**Service information**

**Reference no.:** SDA\_110195

Mandatory action: Replace boiler pin connector in all repairs for Minuto family.

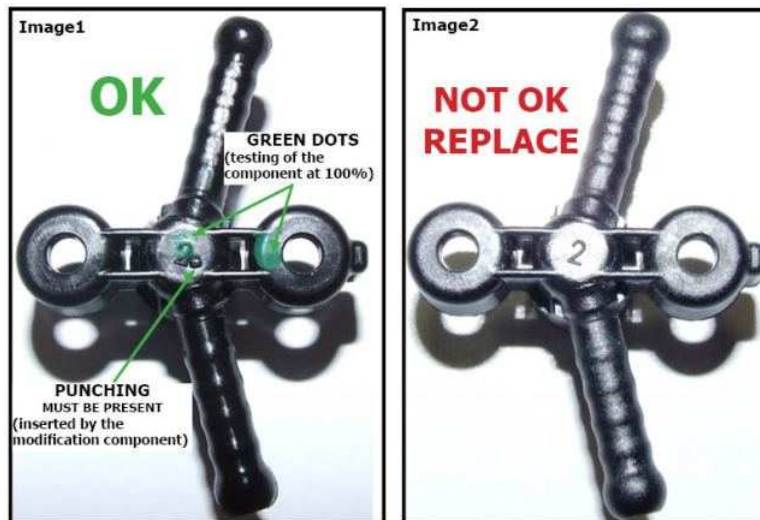
From week 14/2015 the boiler pin connector was improved to avoid leakage (SN relation to production week: image3)

Visual identification of improved connector is possible by the punching on the connector (see image1). All improved connectors will have the visible and tangible punching and two green dots

Code: 421941279742 BLK CONNECTOR FOR PIN BOILER V2 SMR (see image 1)

- 1) In all Minuto machines up to week 13/2015 replace the boiler pin connector by the improved version.
- 2) In case you have stock of the old connector, do not use these any more for repair.  
The spare parts order desk will contact you for taking the appropriate action.
